## ADDENDUM NO. TWO

BID TITLE: **Bid No. 6301 – Arvin High School Modernization: Phase 1A Roofing**

**Arvin High School Phase 1A Roofing**

**ADDENDUM NO. 05**

A4.61

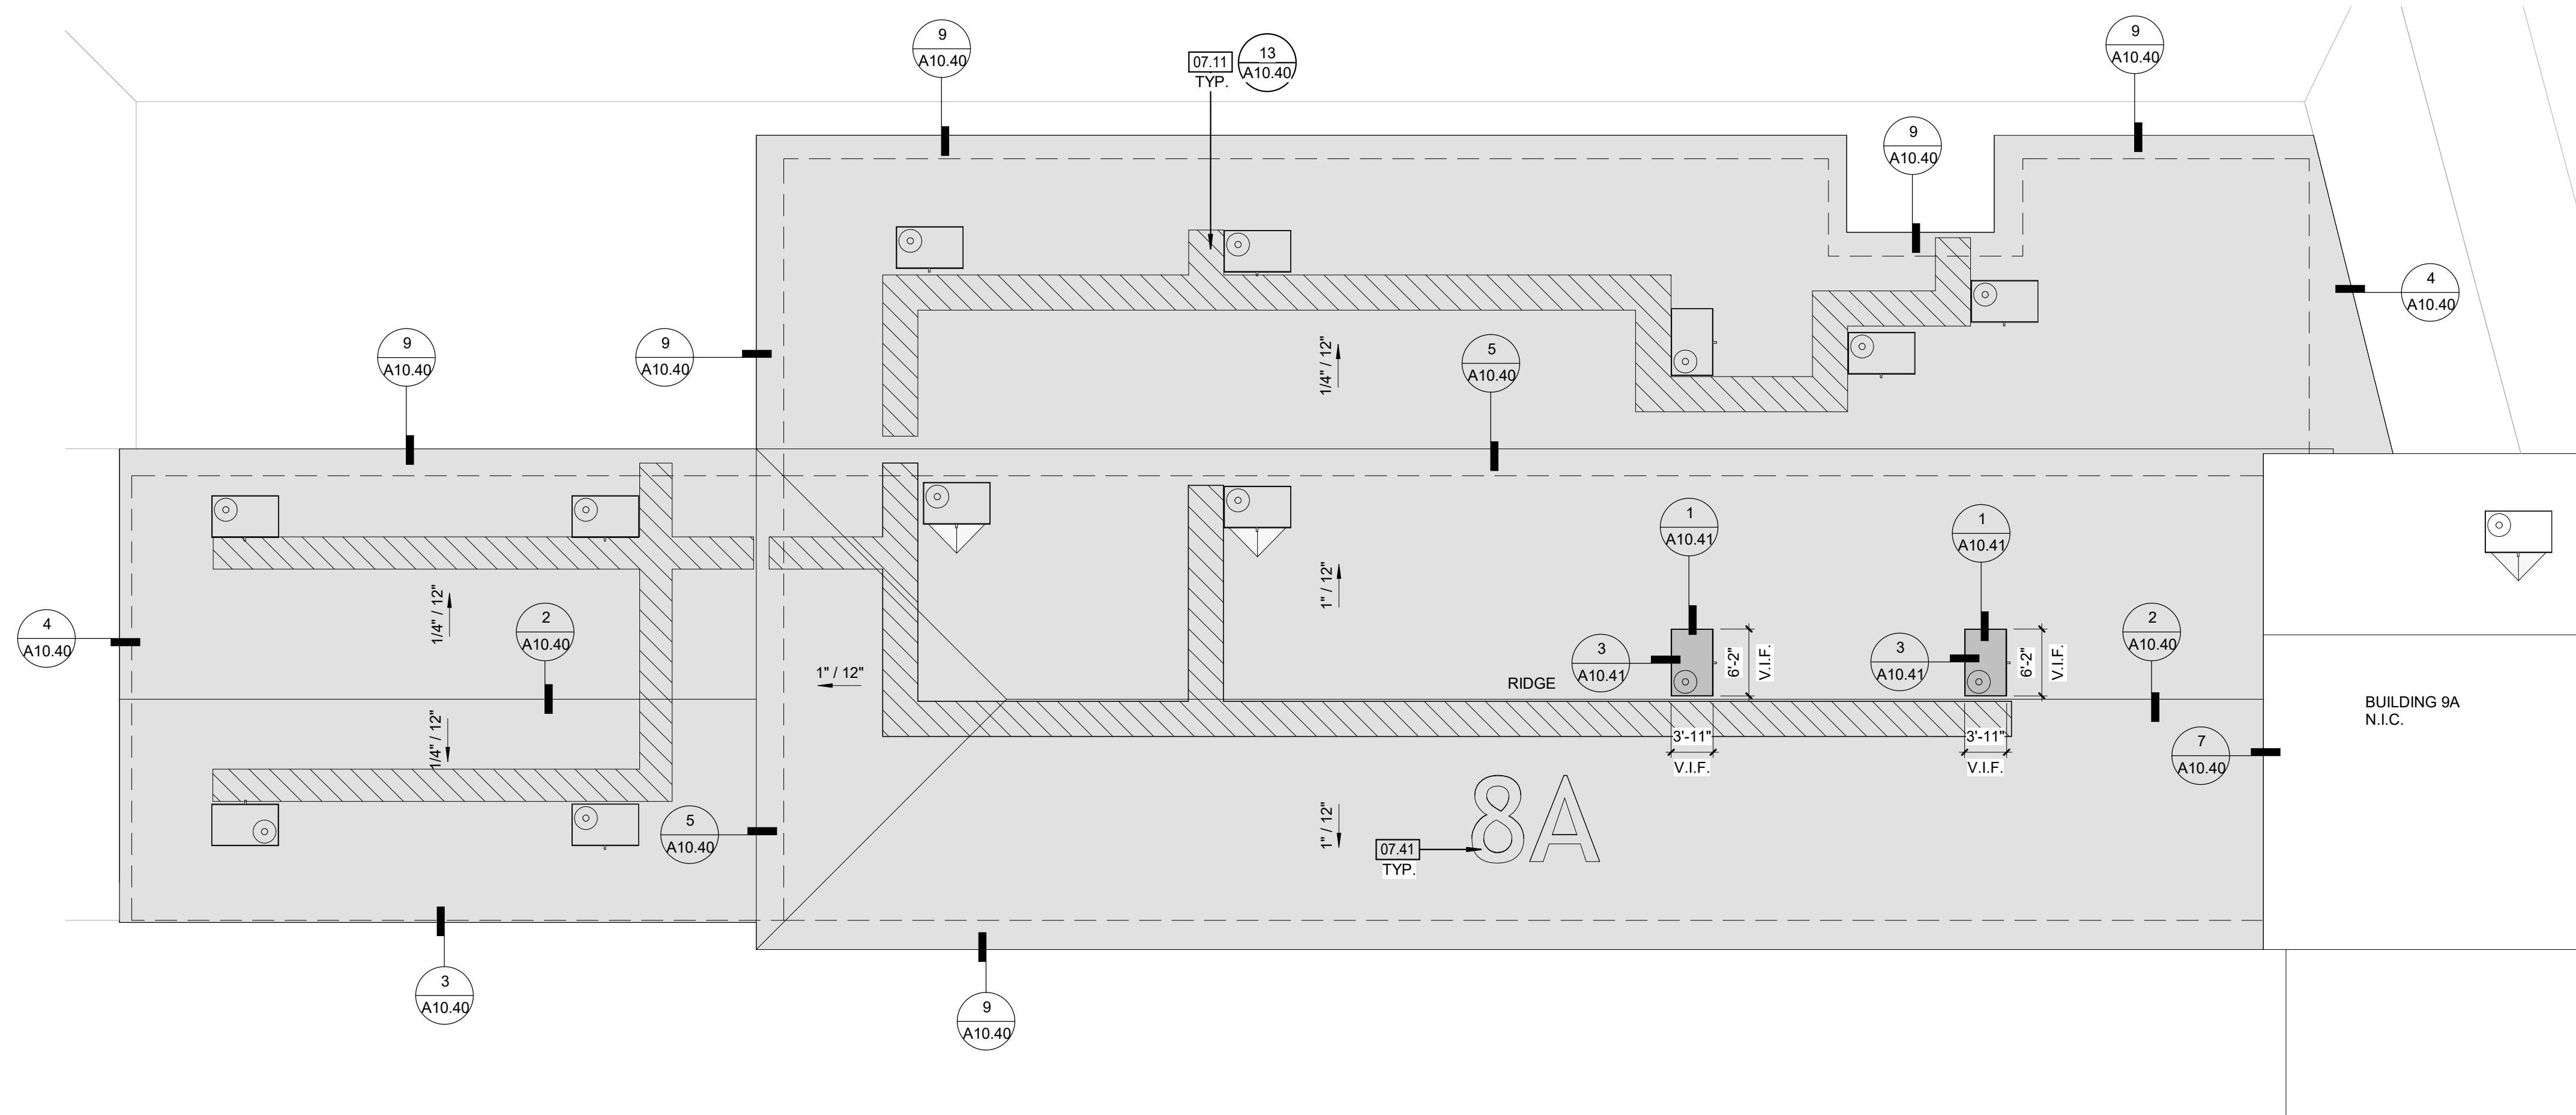
- 1.) ADD & REVISE notes as shown and clouded per Delta 5.

BLDG 8A - ROOF PLAN - DEMO & REMODEL

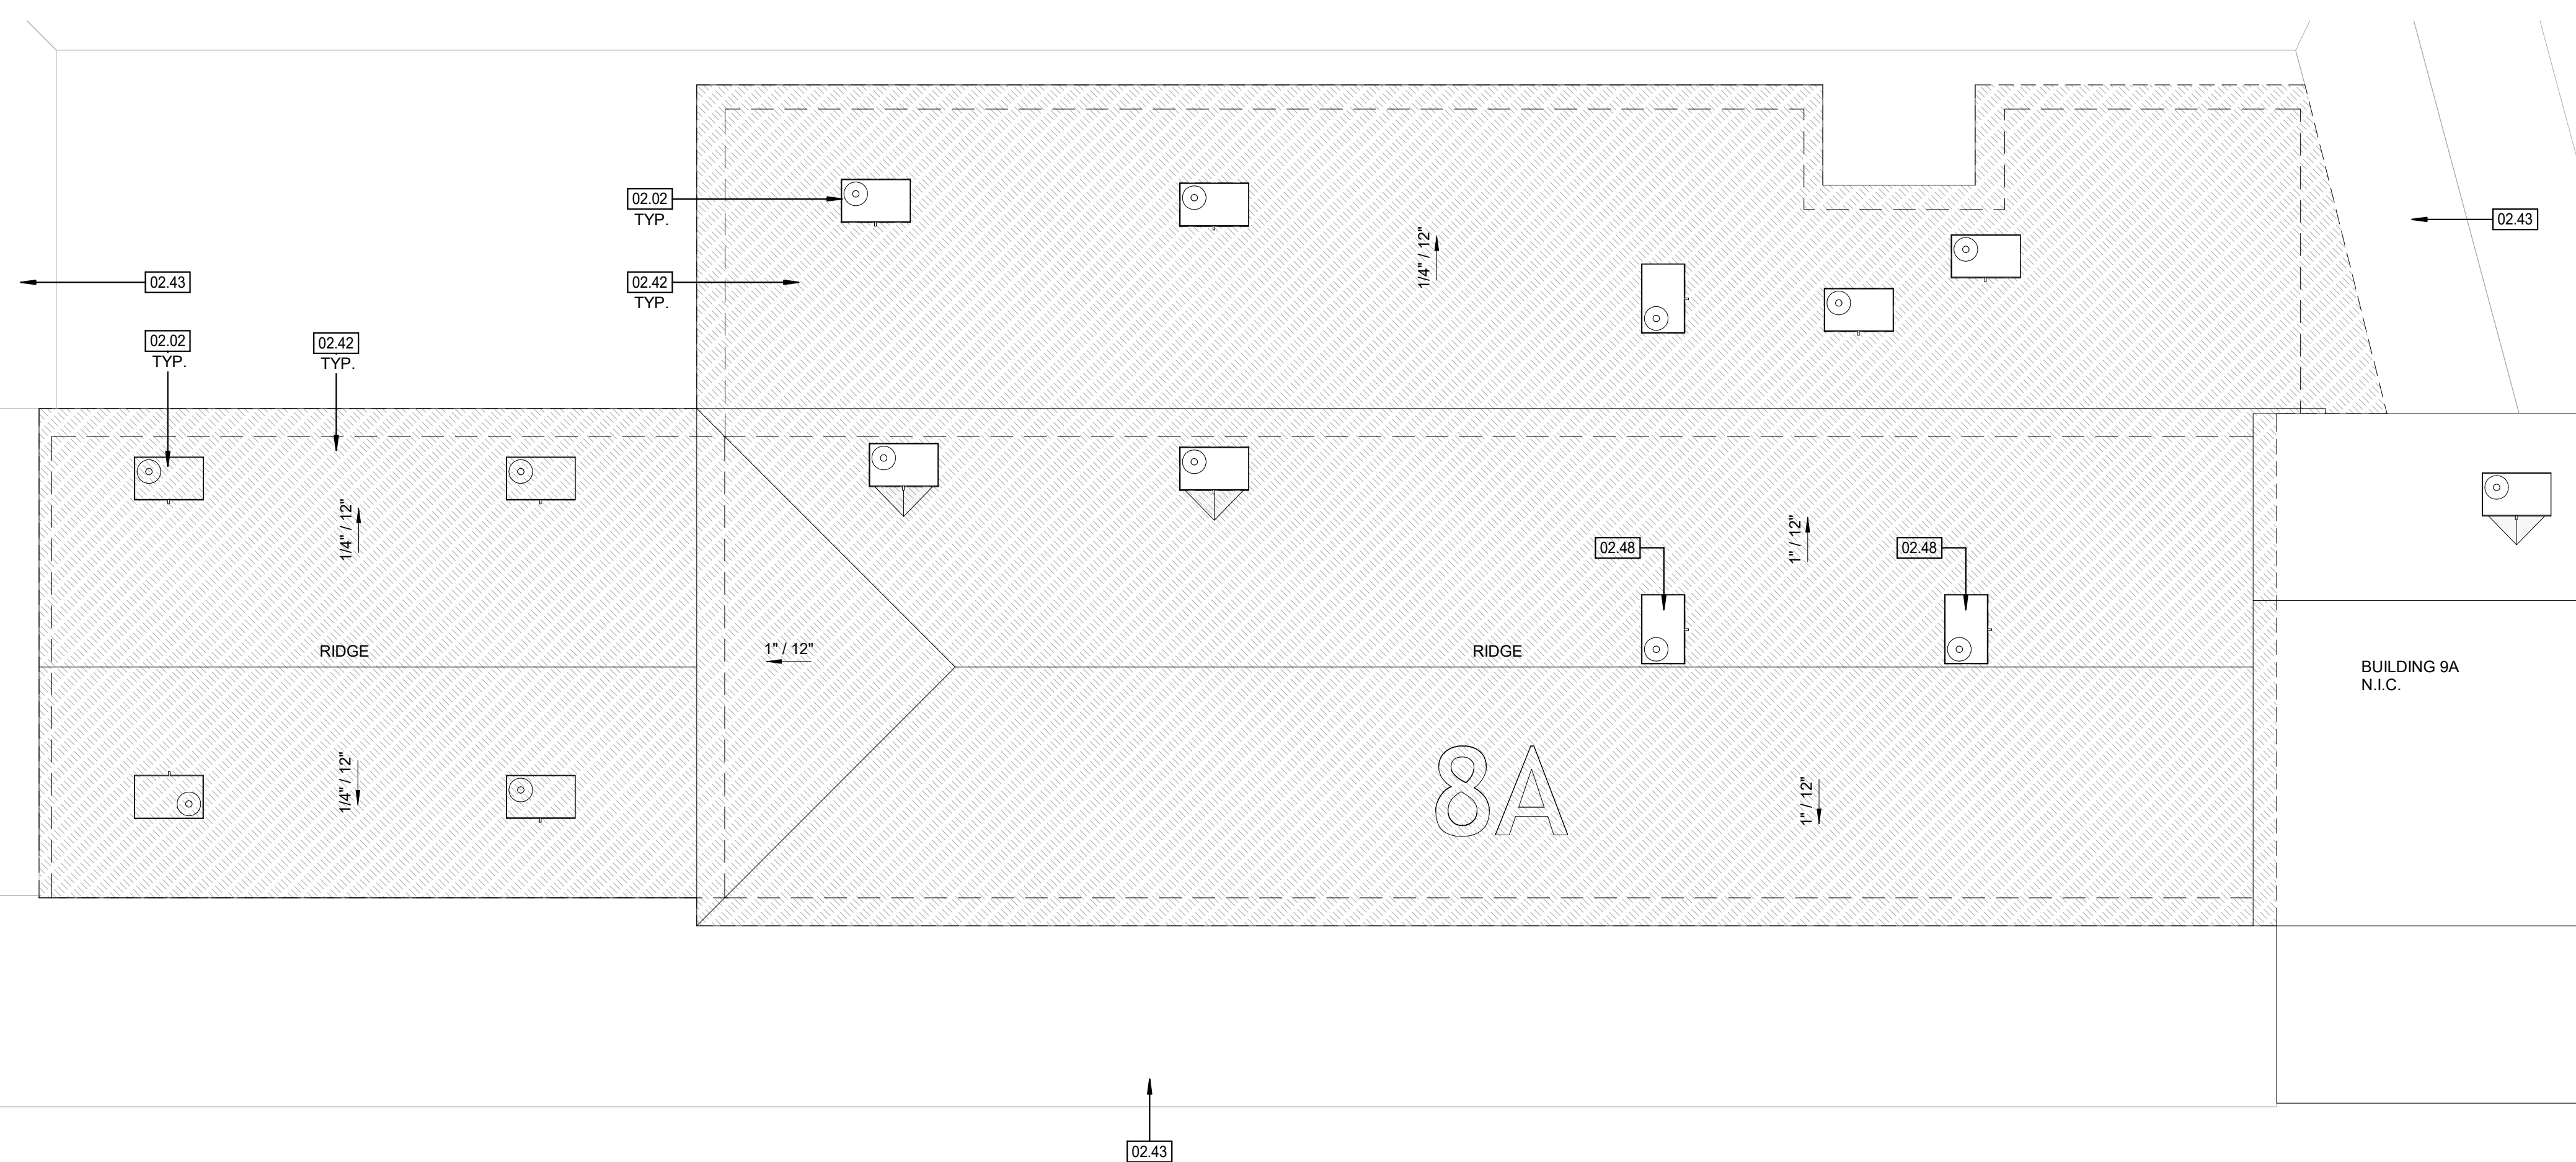
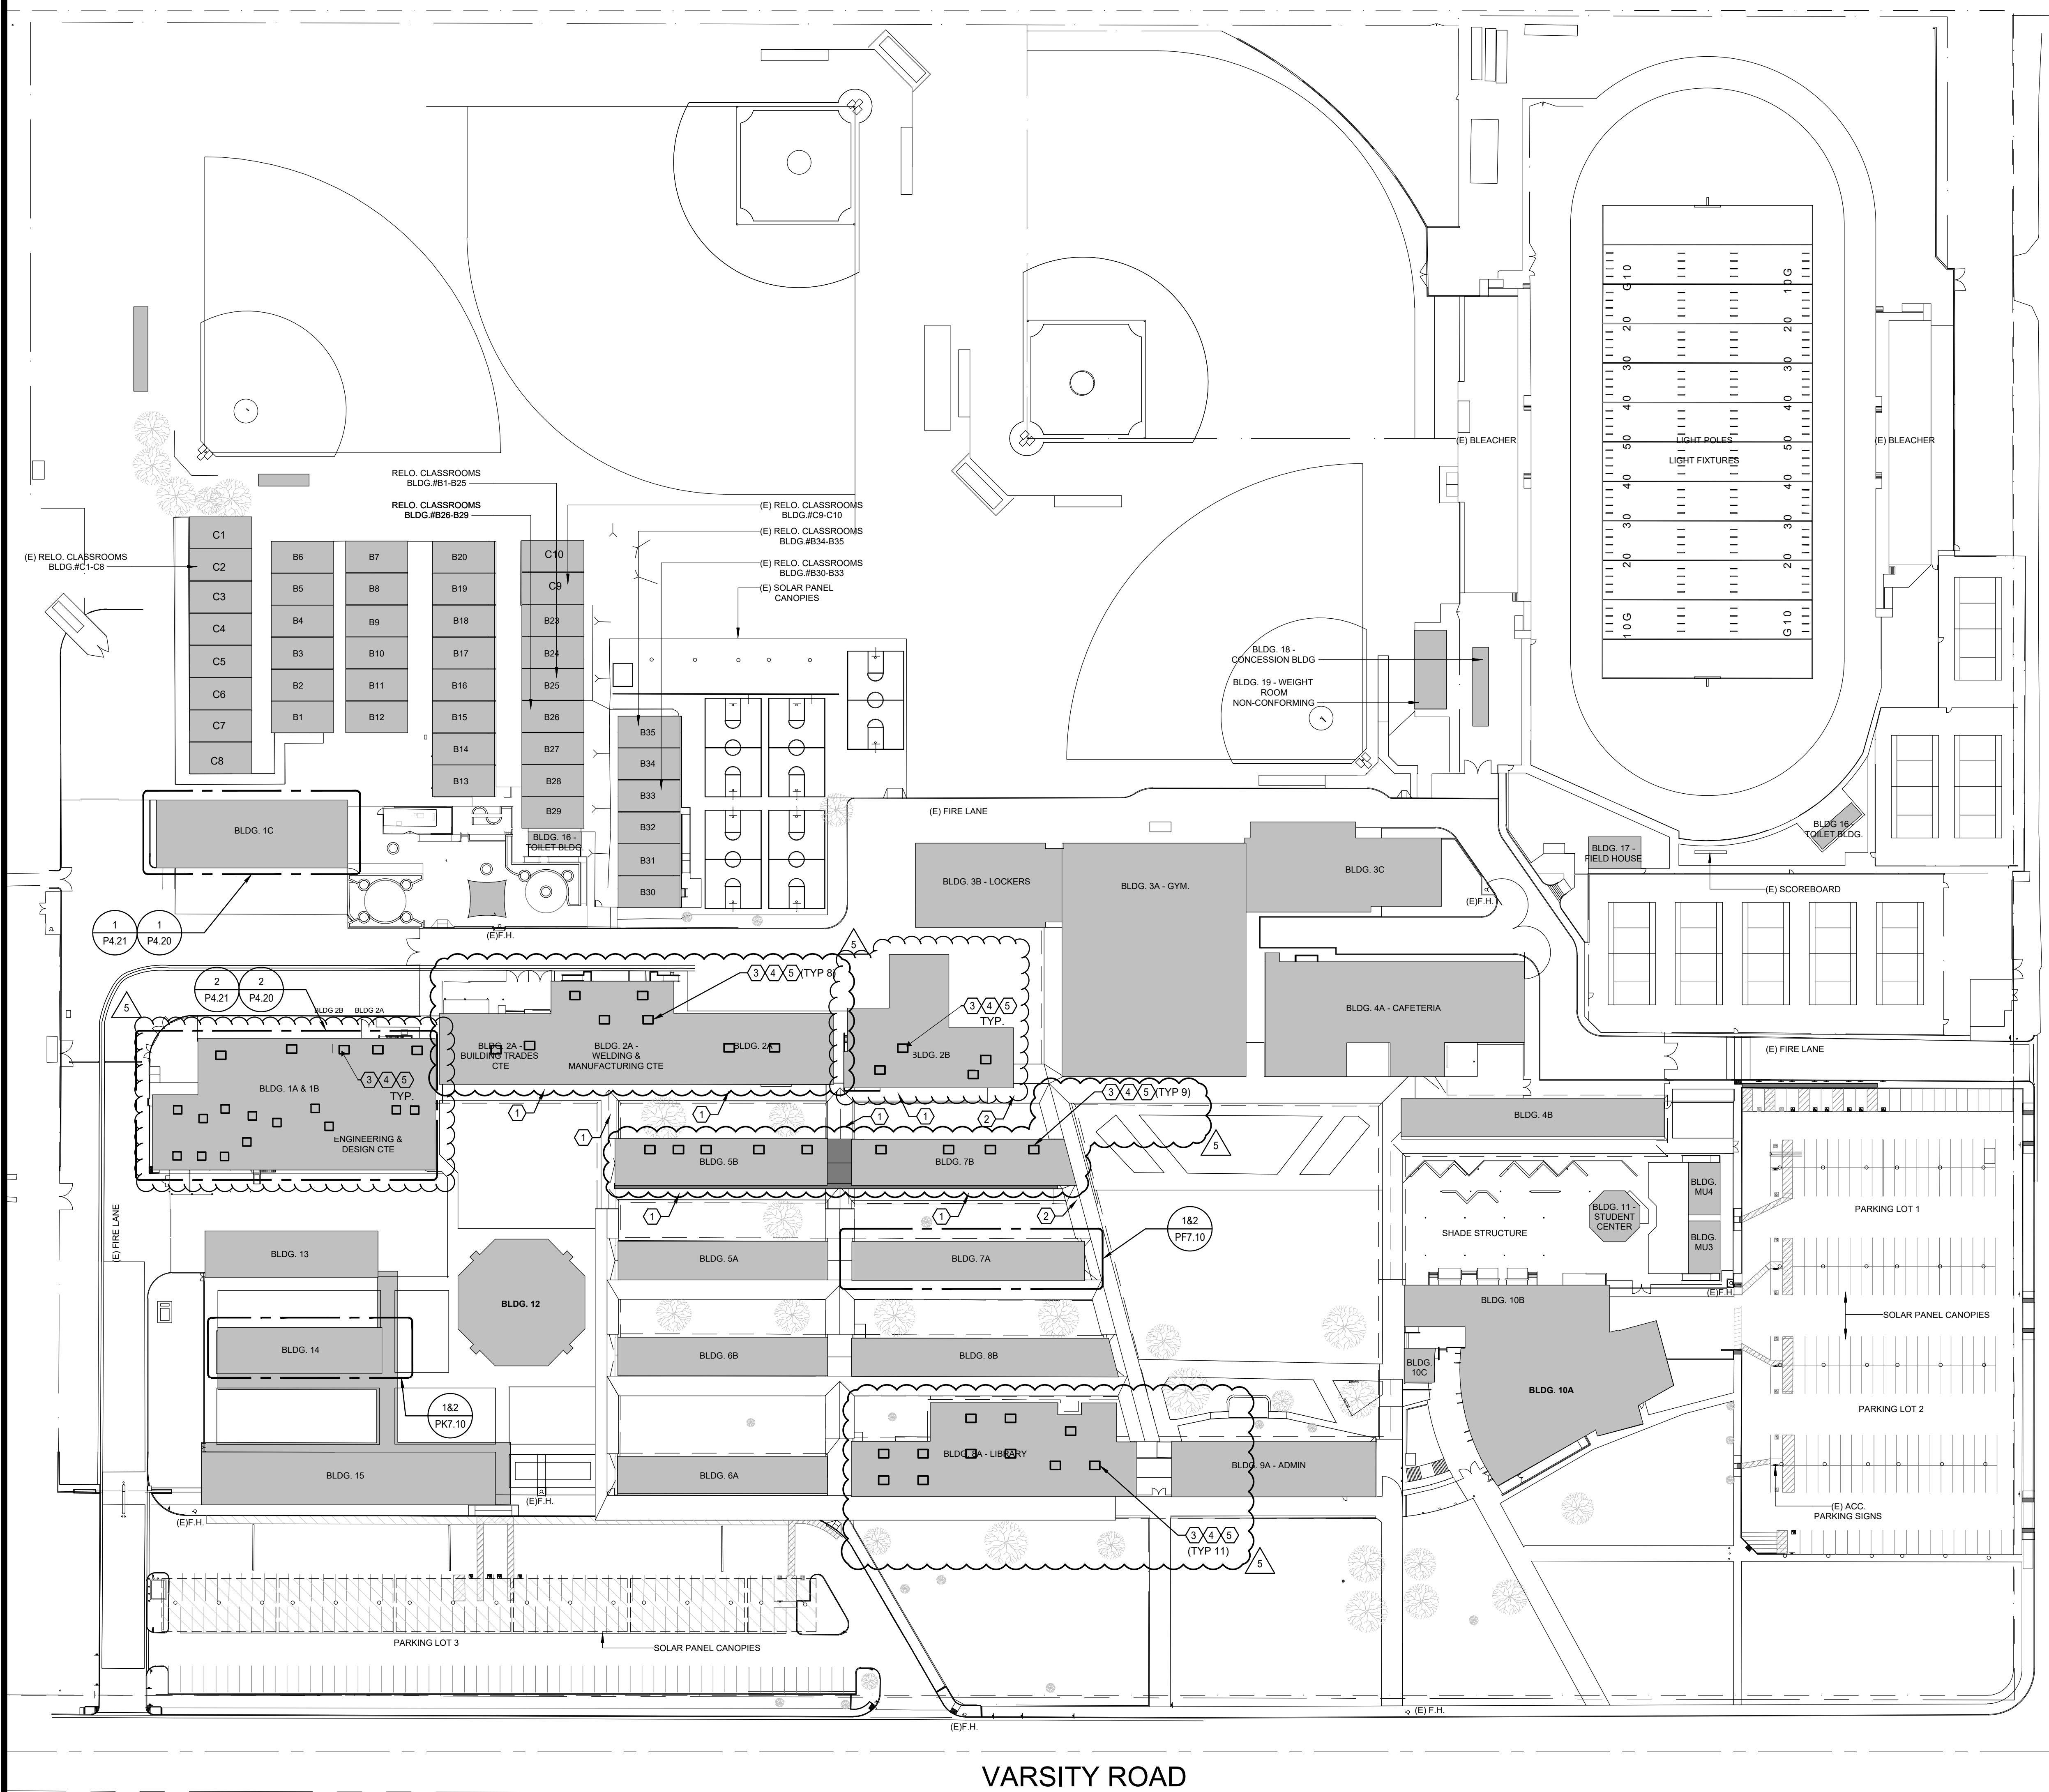
- 1.) REVISE notes as shown and clouded per Delta 5.

**QUESTION:** Sheet A4.70 calls our Keynote 02.02 Typ.

I) Keynote 02.02 states "(E) HVAC UNIT AND CURB TO REMAIN, PROTECT IN PLACE CURB ROOF MEMBRANE FLASHING PER DETAILS 1/A10.41 AND 3/A10.41"

1. Details 1,3/A10/41 callout new roof blocking and wood framed platforms.

a. Are all Keynote 02/02 locations requiring new roof blocking and wood framed platforms? Or are only the (2) units with Key note 02.48 on 1/A4.70 requiring new wood framed platforms?

Only two HVAC units are called out as Keynote 02.48 for new roof blocking and wood-framed platforms per Details 1 and 3 on Sheet A10.41. All other existing HVAC units follow Keynote 02.02 and Details 6 and 8 on Sheet A10.41. Please also refer to CCD 1-A for additional information.
